Origination Form
Proposed Revisions to a Standard Plans Index

Originator:	Turley, Joshua	Index Number:	455-031
Date:	5/15/2025	Sheet Number(s):	Sheet 1
E-mail:	Joshua.Turley@dot.state.fl.us	Index Title:	30" SQUARE PRESTRESSED CONCRETE PILE - HIGH MOMENT CAPACITY

LAST REVISION 11/01/23 11/01/25	DESCRIPTION:	2026-27 FY 2025-26 STANDARD PLANS	30" SQUARE PRESTRESSED CONCRETE PILE - HIGH MOMENT CAPACITY	INDEX 455-031	SHEET 1 of 1
---	--------------	--	--	-------------------------	------------------------

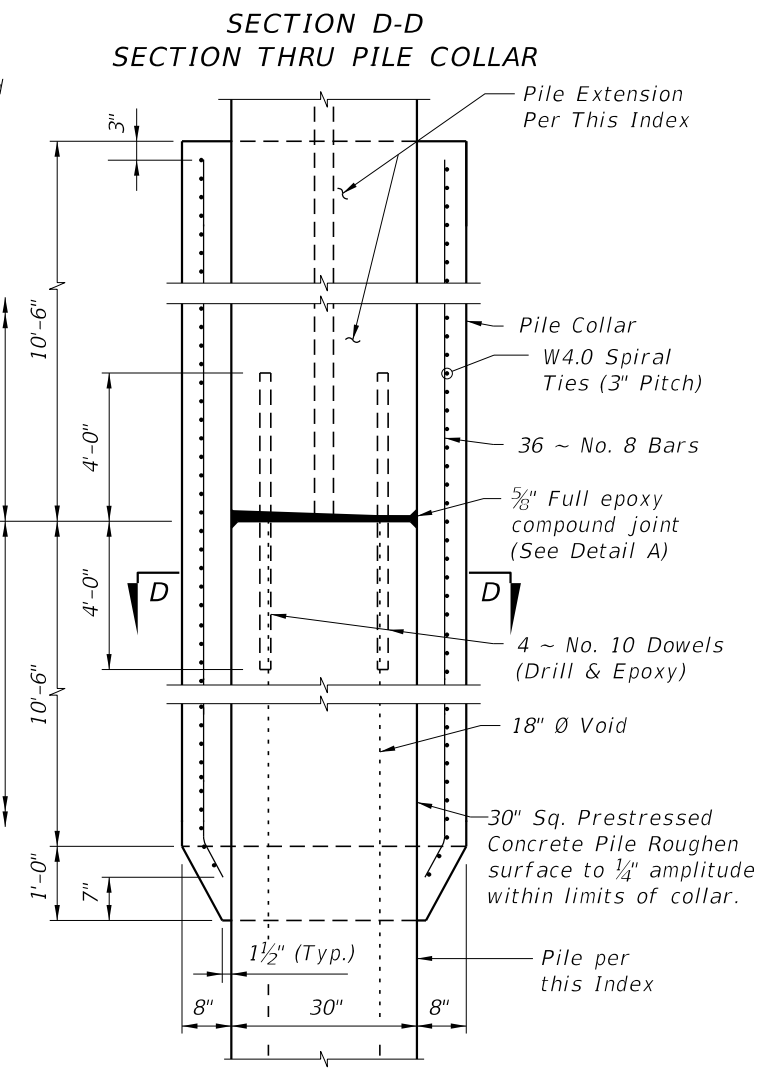
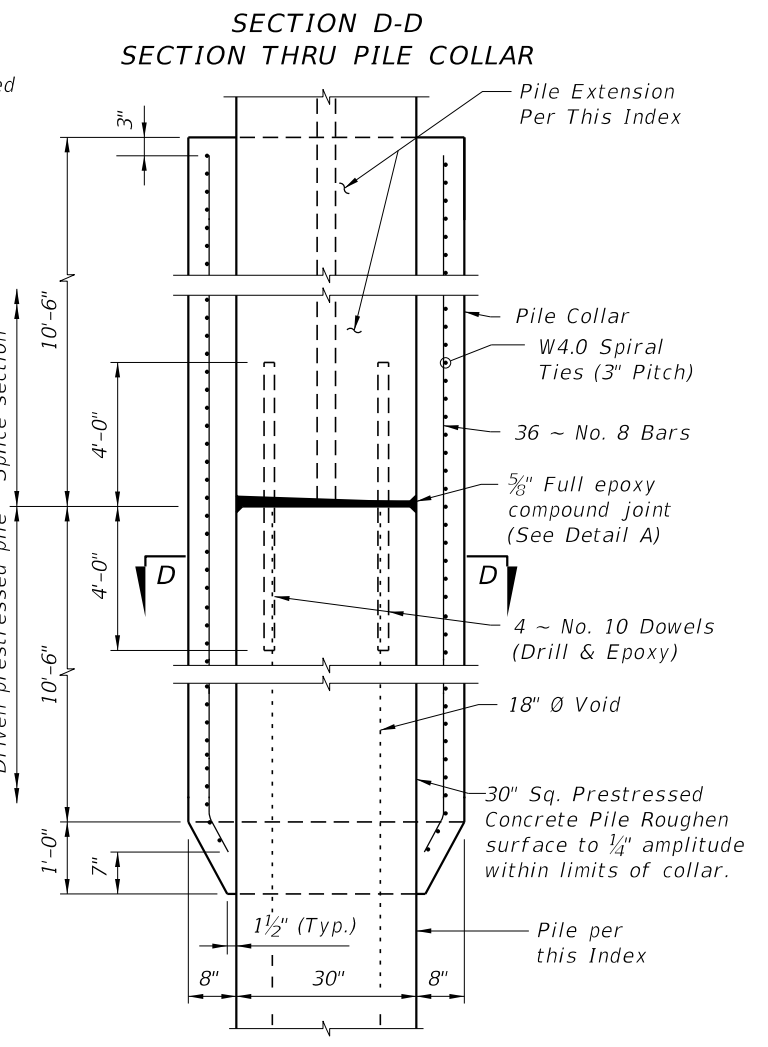
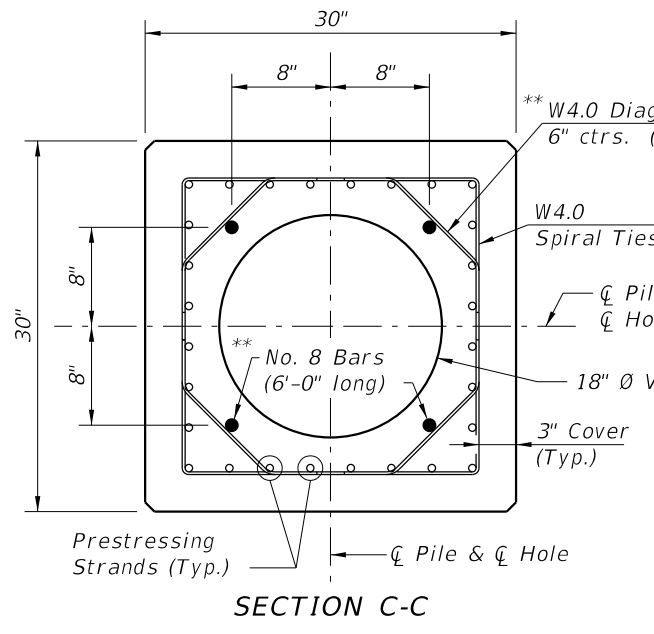
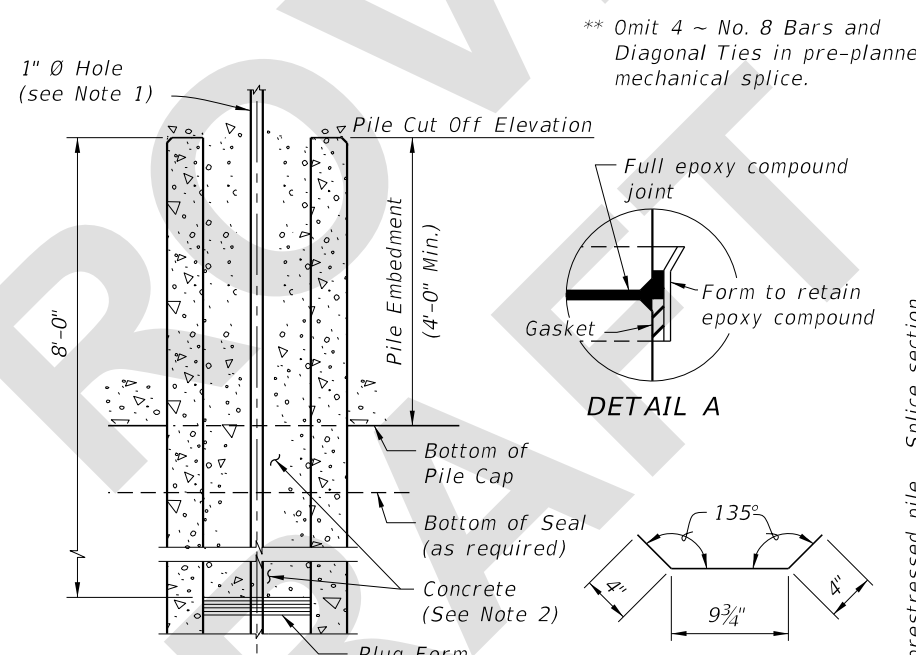
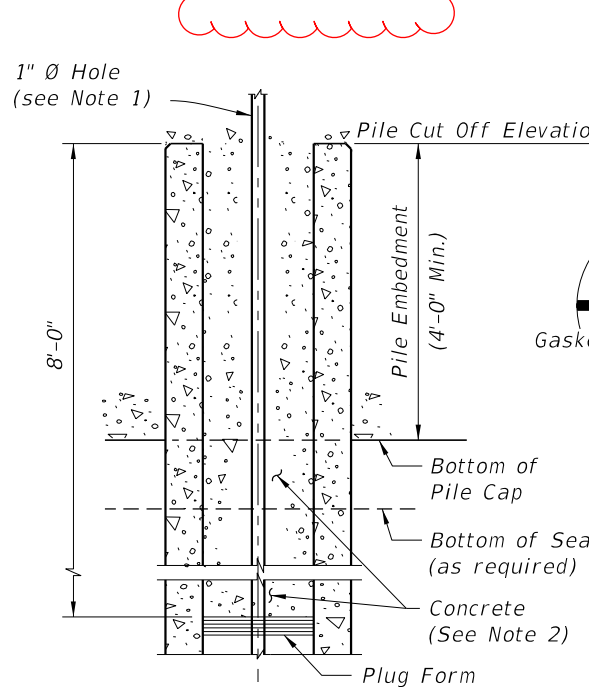
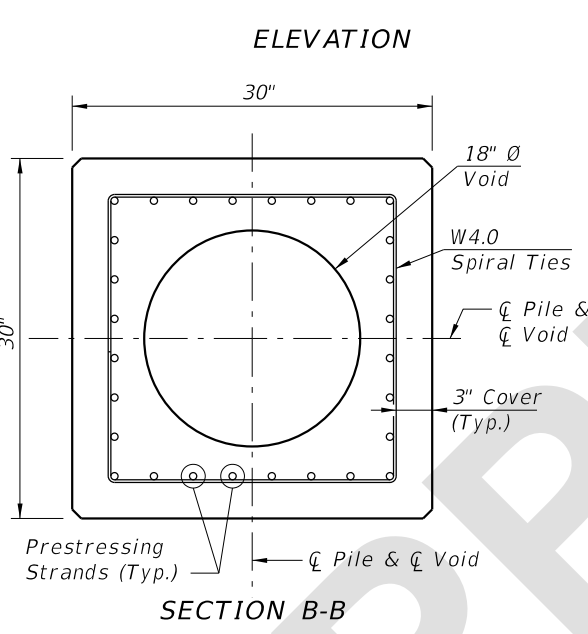
Sheet 1: Changed pitch spacing for spiral ties and removed errant 11' dimension which was a CAD error.

Vertical cracking has been observed in hollow core prestressed concrete piles, including 30-in. voided square HMC and conventional piles, and 60-in. hollow cylindrical piles, during installation and service. To address cracks frequently occur within the 4" stirrup pitch zone, a reduction in stirrup pitch to 2" is proposed to help mitigate cracking in these areas.
